# CITY OF ALBUQUERQUE

**Re: Beyond Health Office Building  
3700 Bosque Plaza Ln. NW  
30-Day Temporary Certificate of Occupancy  
Transportation Development Final Inspection**  
Engineer's/Architect's Stamp dated 8-19-20 (E12D006H)  
Certification dated 4-20-21

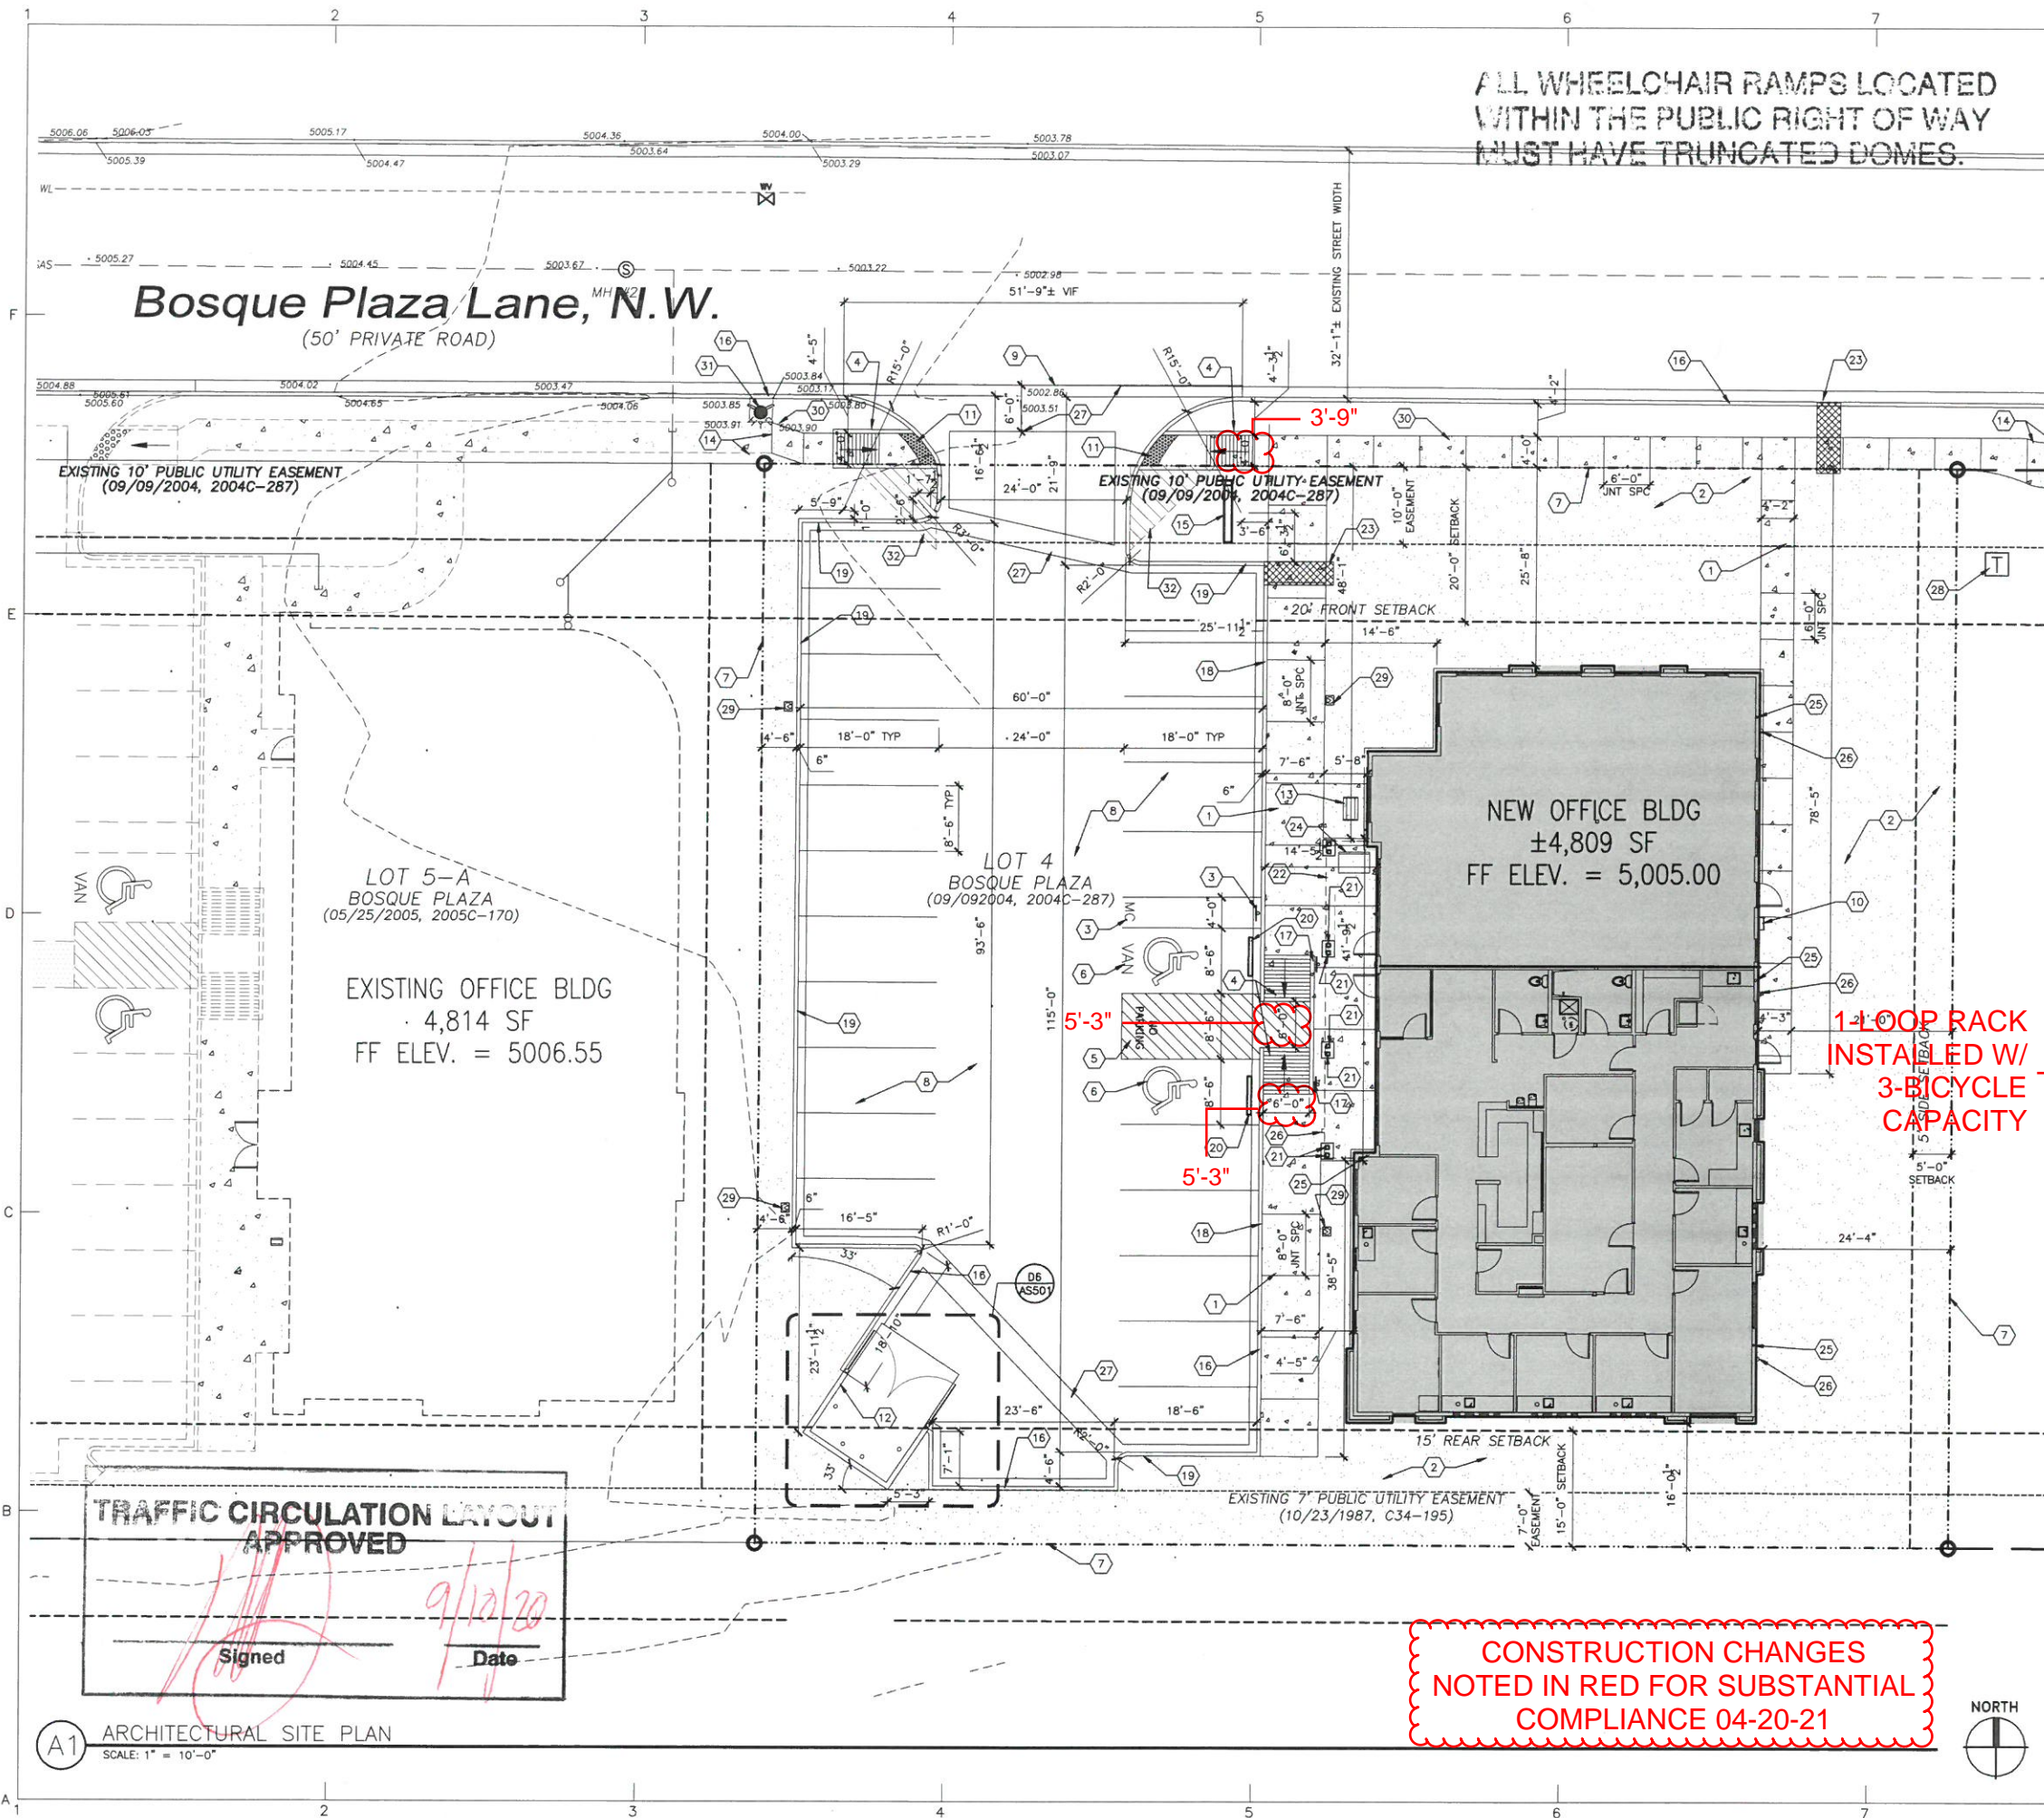
- Please provide pictures of dried concrete. (See Attached Photos)
- Please remove construction debris and equipment from site.
